JOSEPH R. BLASDEL
Sheet: /
File: Philco 46-480 Schematic.kicad_sch

**Title: PHILCO 46-480 SCHEMATIC**

| Size: E | Date: 2025-05-05 | Rev: 1 |

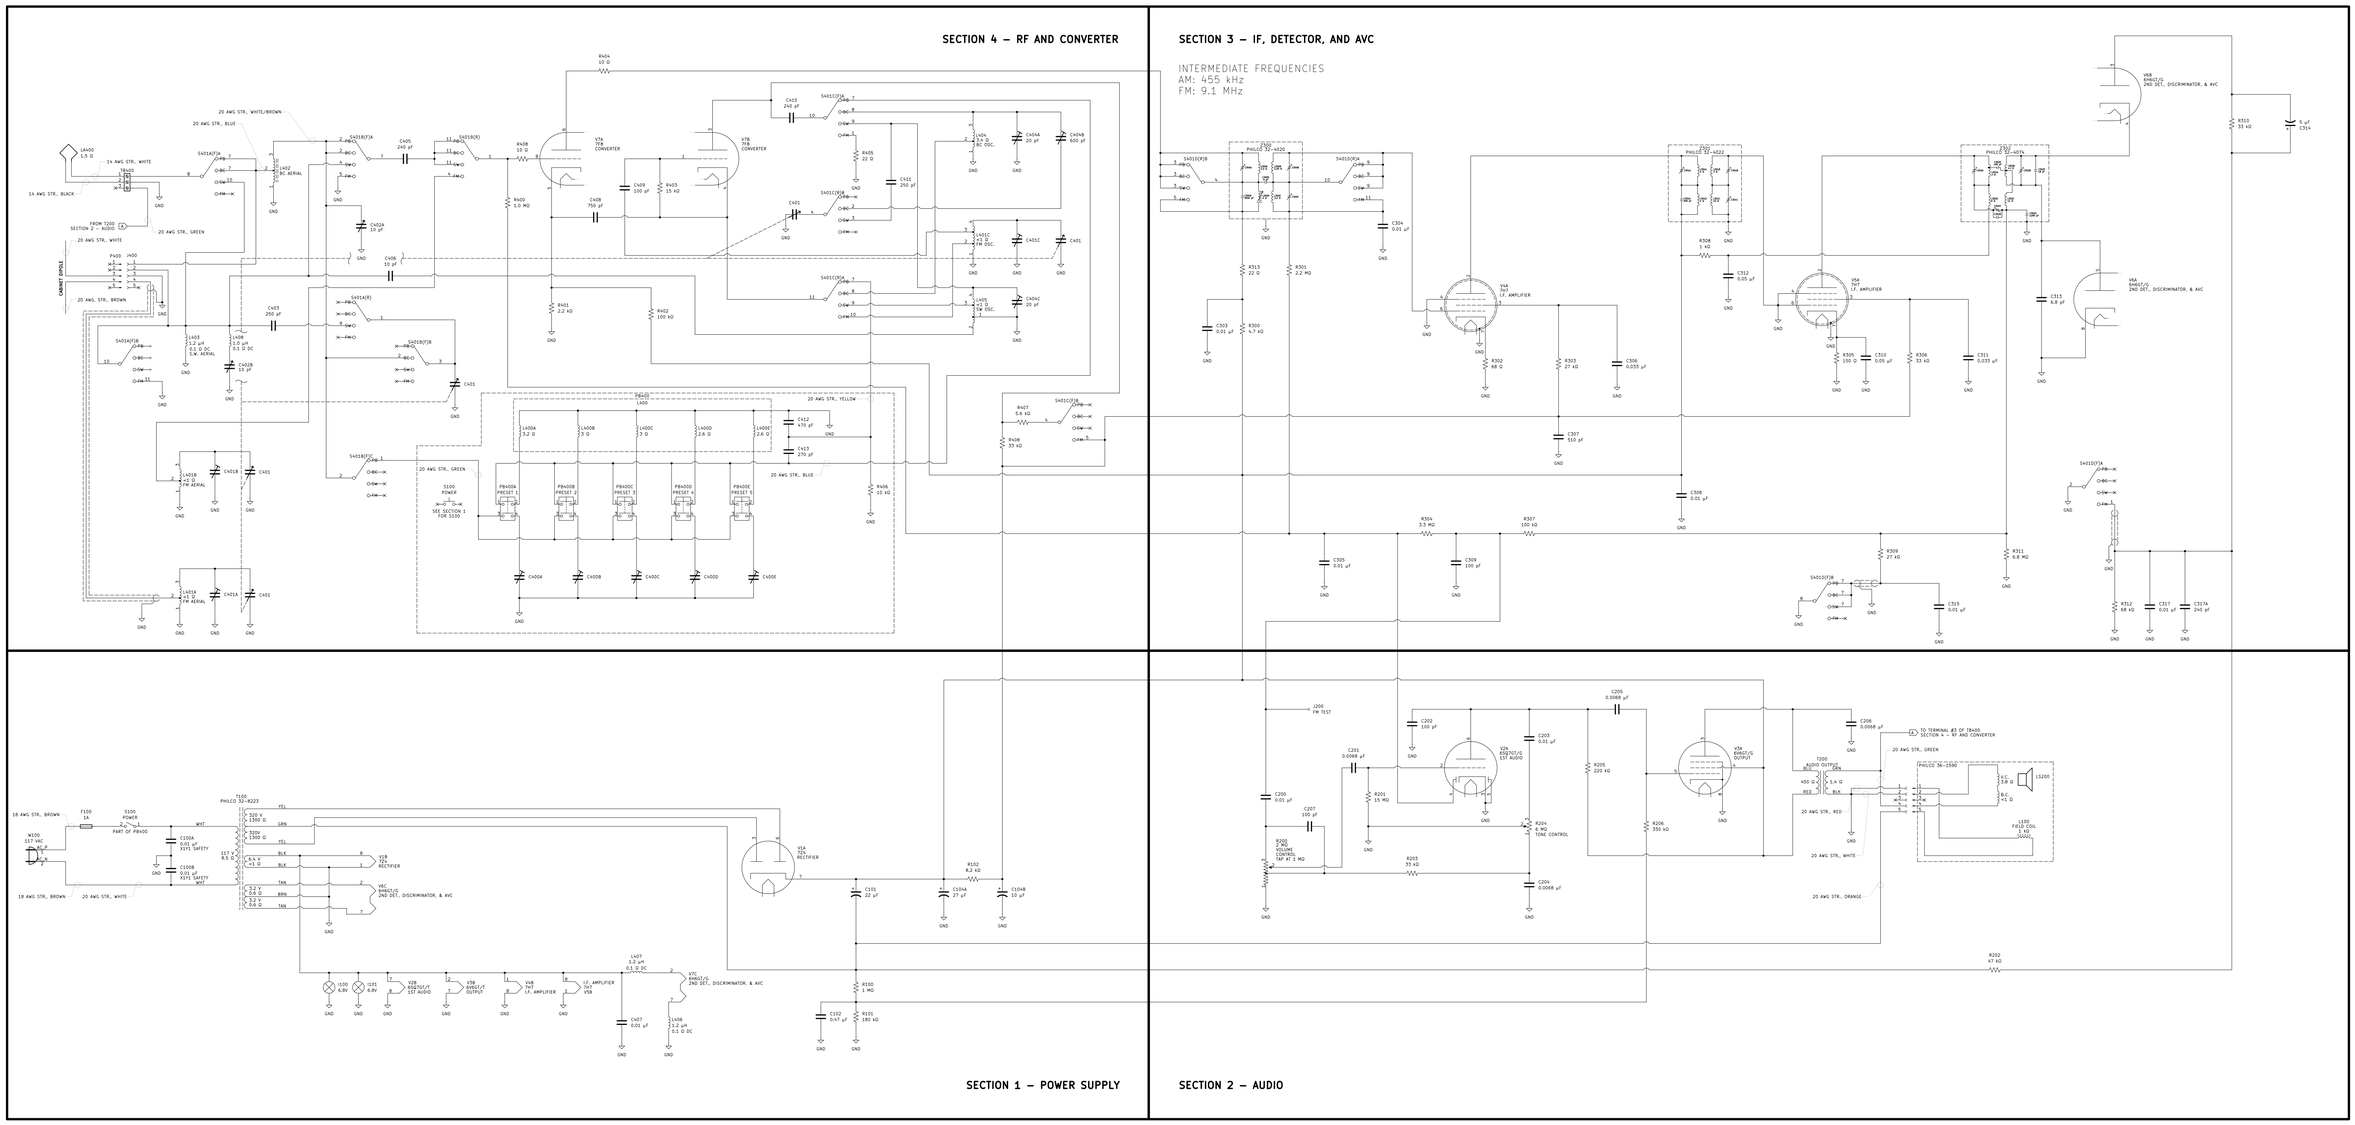
REV 1 CHANGES
* W100 REPLACED BY POLARIZED PLUG.
* F100 MOVED FROM NEUTRAL TO HOT SIDE OF 117 VAC CIRCUIT.
* S100 MOVED FROM NEUTRAL TO LINE SIDE OF PRIMARY 117 VAC CIRCUIT.
* C316A RENAMED TO C317A. IT IS IN PARALLEL TO C317. AND C316 WAS REMOVED DURING PRODUCTION RUN 9.
* C100A & C100B MOVED DOWNSTREAM OF S100, SO AS TO BE DE-ENERGIZED WHEN RADIO POWERED OFF.
* C100A & C100B UPGRADED TO X1Y1 RATED SAFETY CAPACITORS.
* C102 CHANGED FROM 25 µF TO 22 µF.
* C102 CHANGED FROM 0.5 µF TO 0.47 µF.
* C104A, C104B CHANGED FROM 10 µF TO 15 µF.
* C201, C204, C205, C208 CHANGED FROM 0.006 µF TO 0.0068 µF.
* C306, C311 CHANGED FROM 0.01 µF TO 0.033 µF.
* C402A, C402B CHANGED FROM 10 µF TO 20 µF.
* C403 CHAS CHANGED FROM 250 µF TO 200 µF.
* C412 CHANGED FROM 485 µF TO 470 µF.
* C413 CHANGED FROM 285 µF TO 270 µF.
